COMMUNITY DEVELOPMENT DEPARTMENT
80 Columbia Avenue ♦ Marysville, WA 98270
(360) 363-8100 ♦ (360) 651-5099 FAX

Re: PA22-015 - Colvin PRD – Technical Review 1

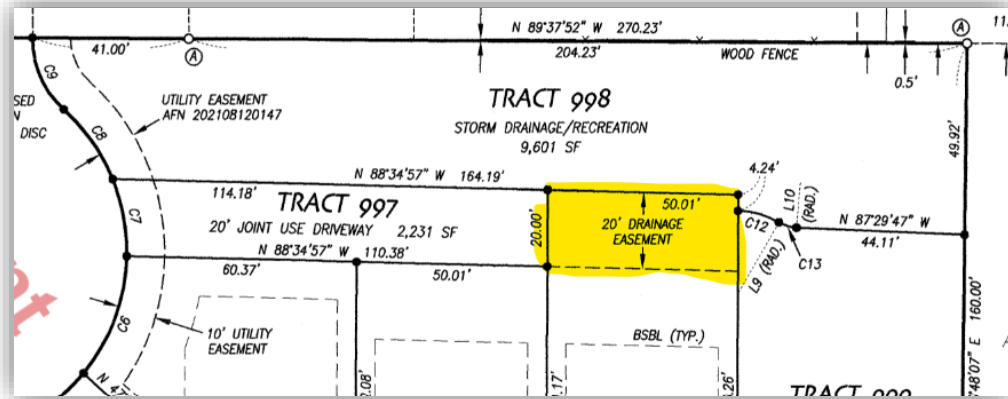
10. To provide access to the stormwater vaults, please provide a stormwater/drainage easement on Lot 11 to allow for unhindered vector truck access. See example below:
